InsideOut - Roof Project Addendum No. 002

CDBG FY2020 InsideOut - Roof

INSIDEOUT ROOF

ROOF PLAN

1 **ROOF PLAN**
A101 1/8" = 1'-0"

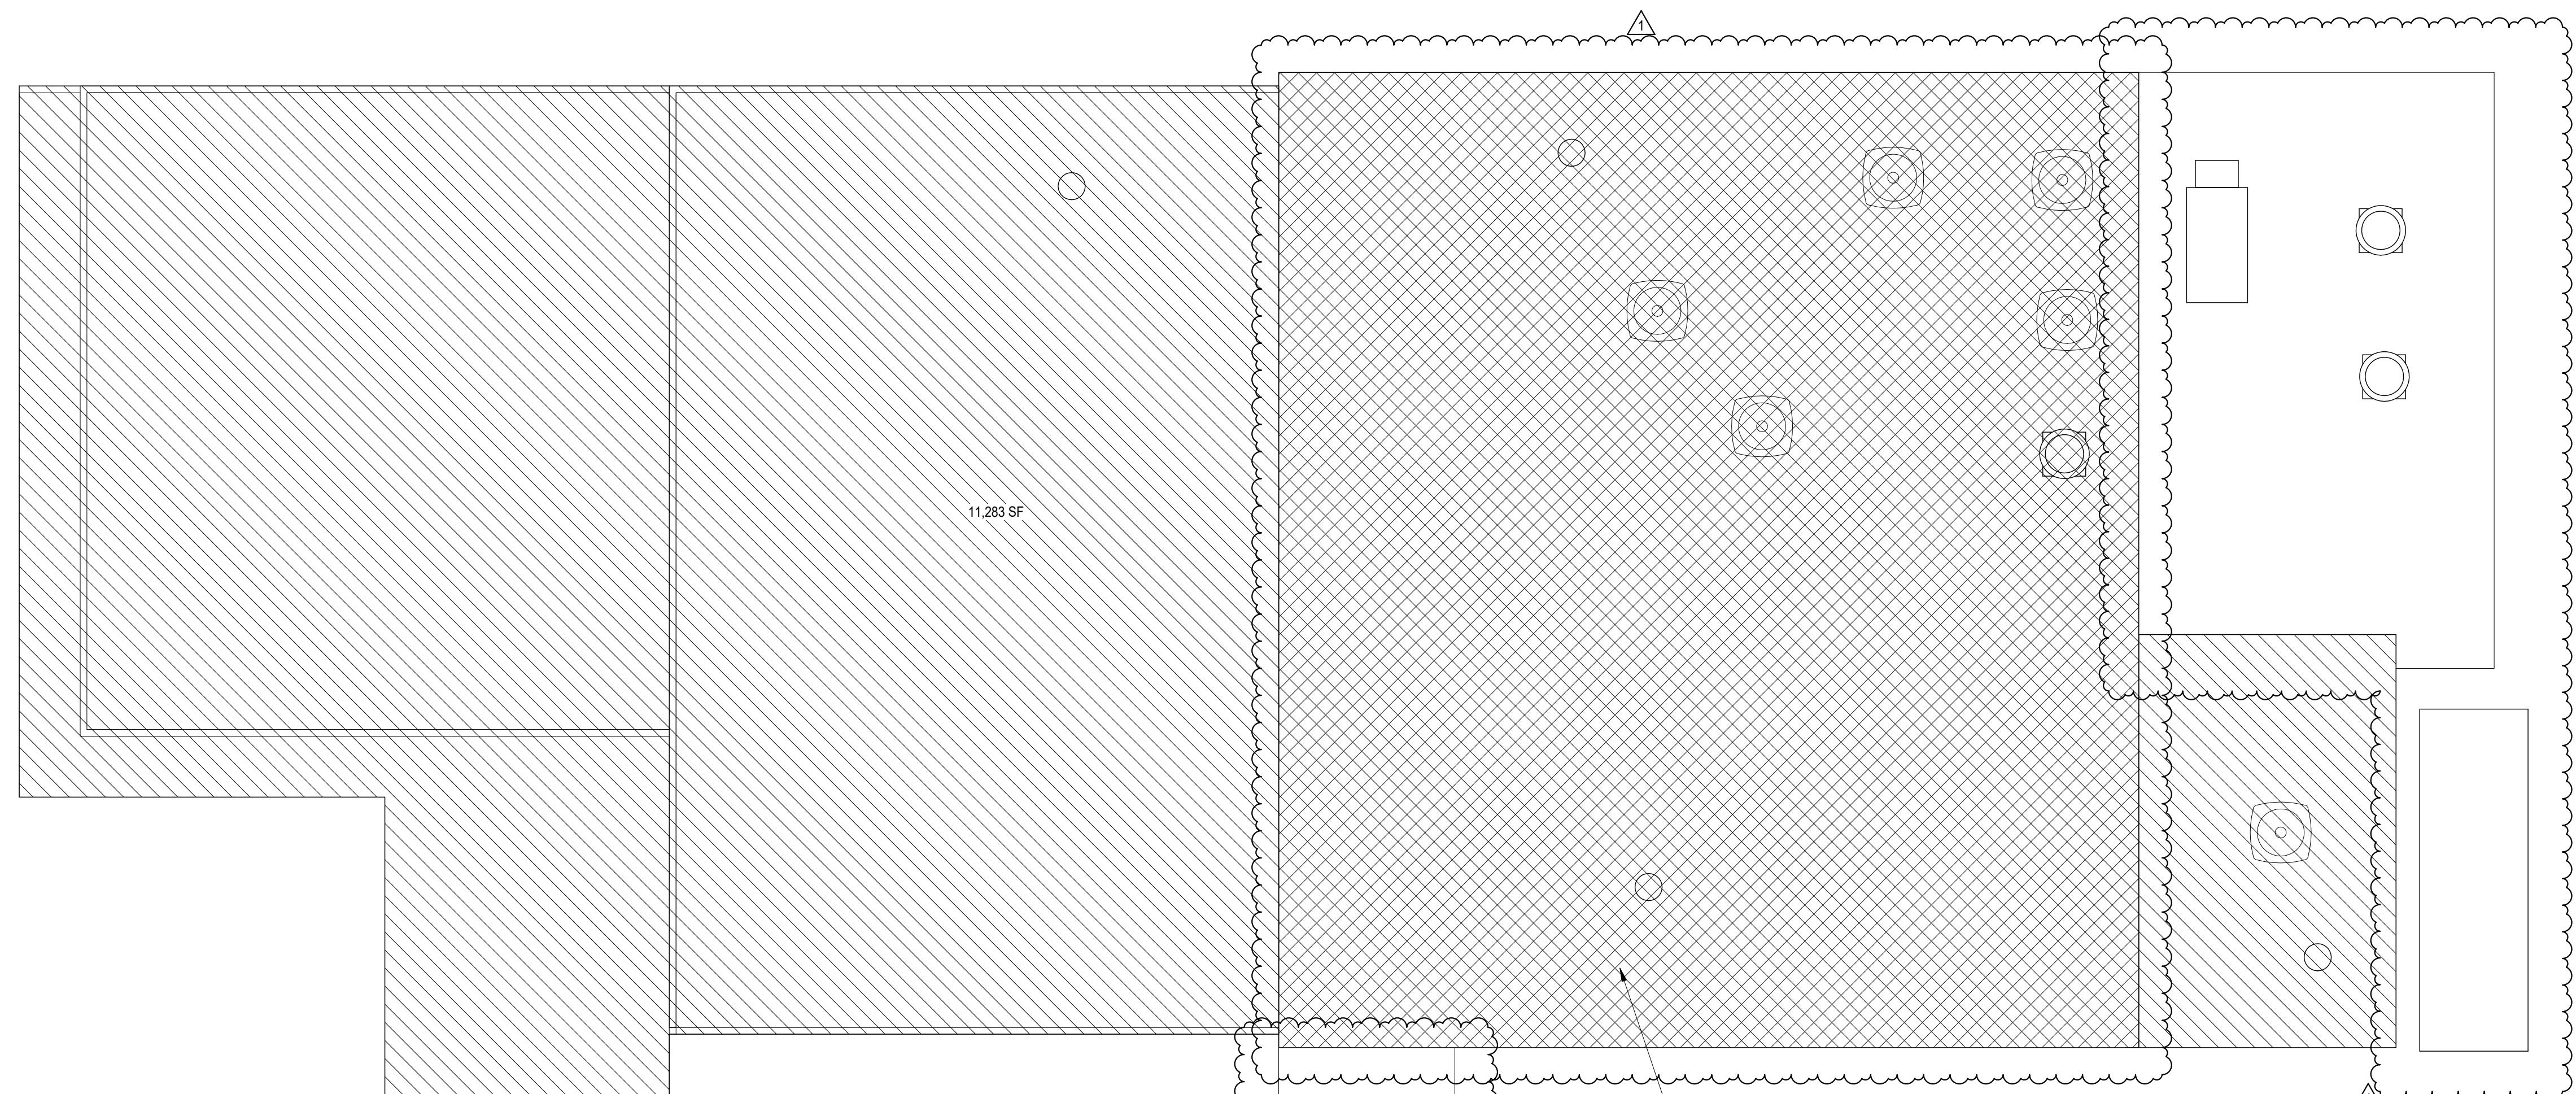
1. Section of roof has two layers and will require tear off (see attached).

REMOVE TWO LAYERS OF ROOF IN THIS AREA DOWN TO SUBSTRATE
